# Groundwater Application Review Summary Form

Application # G: BS33

**PUBLIC INTEREST REVIEW FOR GROUNDWATER APPLICATIONS**

TO: Water Rights Section Date April 17, 2018  
 FROM: Groundwater Section Aurora C Bouchier  
 Reviewer's Name  
 SUBJECT: Application G- 18533 Supersedes review of na  
 Date of Review(s)

Stream Depletion Model Results

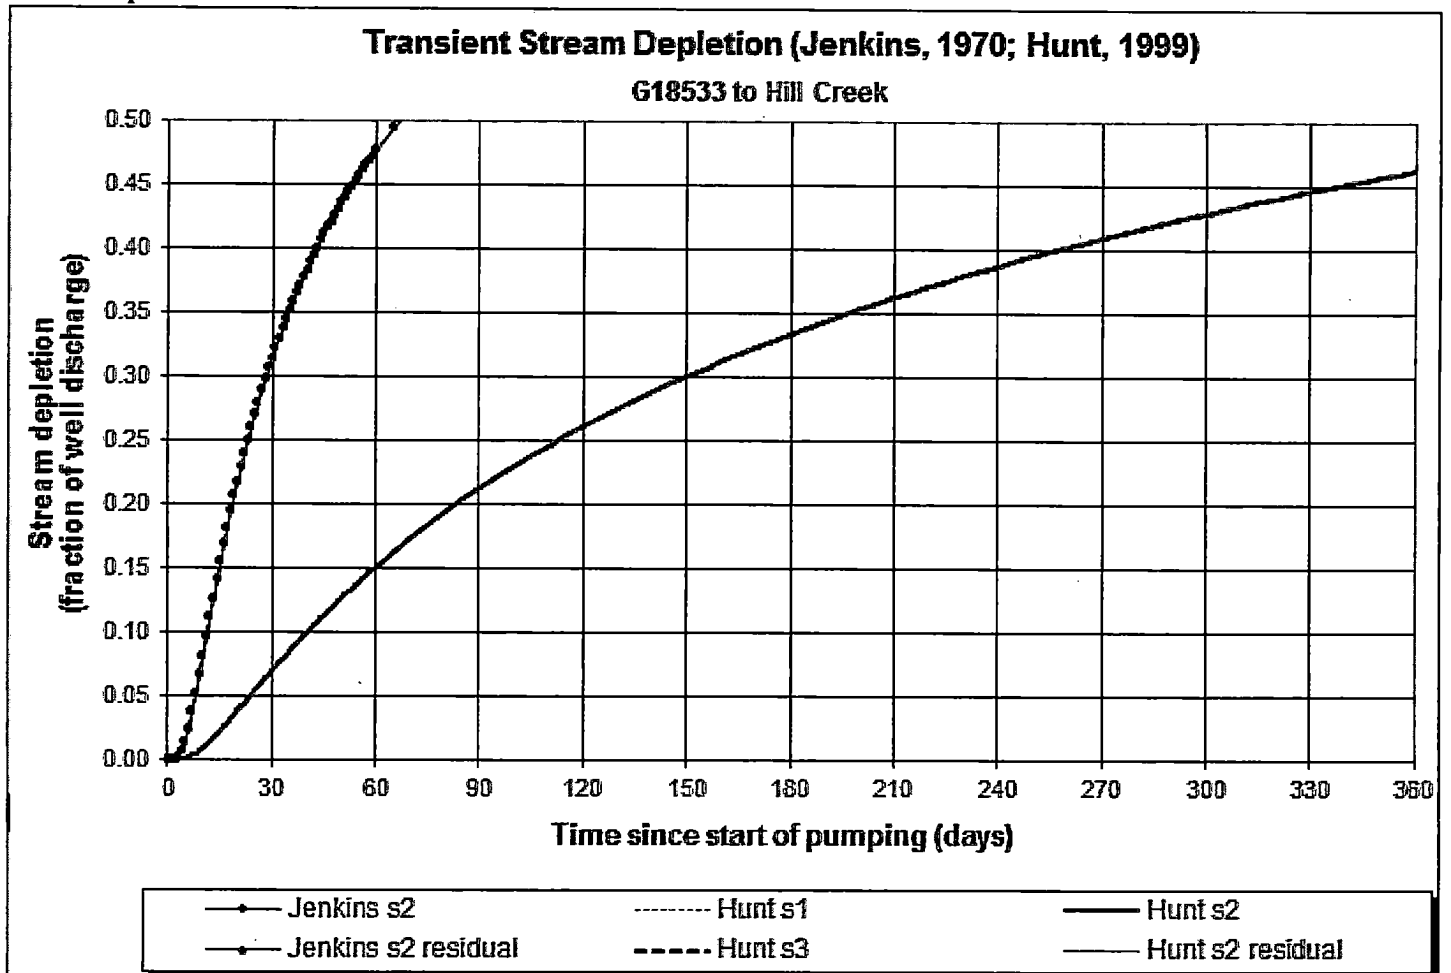
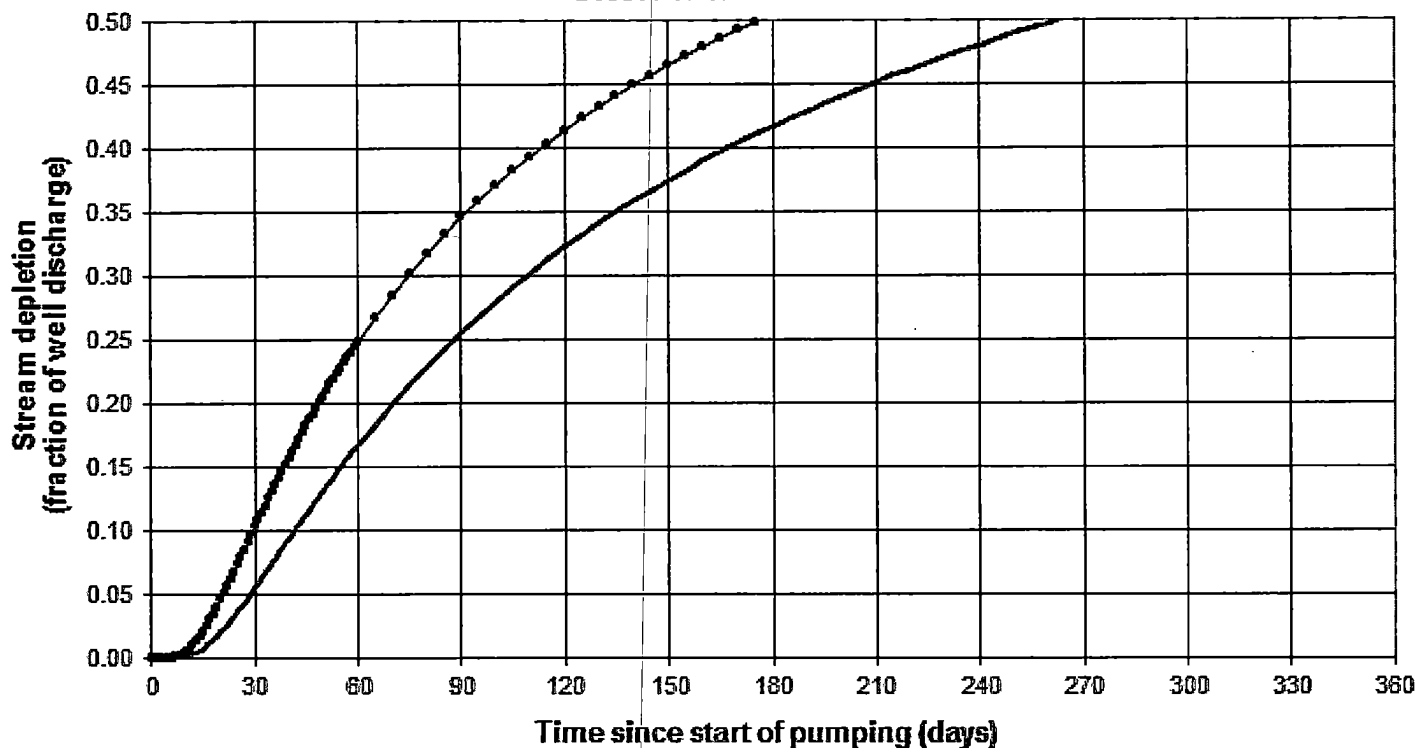
The stream depletion at 30 days was estimated using the Hunt 1999 model and assuming a 3 foot clogging layer beneath the streambed.

C6. **SW / GW Remarks and Conditions:** \_\_\_\_\_  
Stream depletions at 30 days is modeled to be less than 25%. However, stream depletion will increase over time until all of the pumped water is balanced by reduced stream flow.
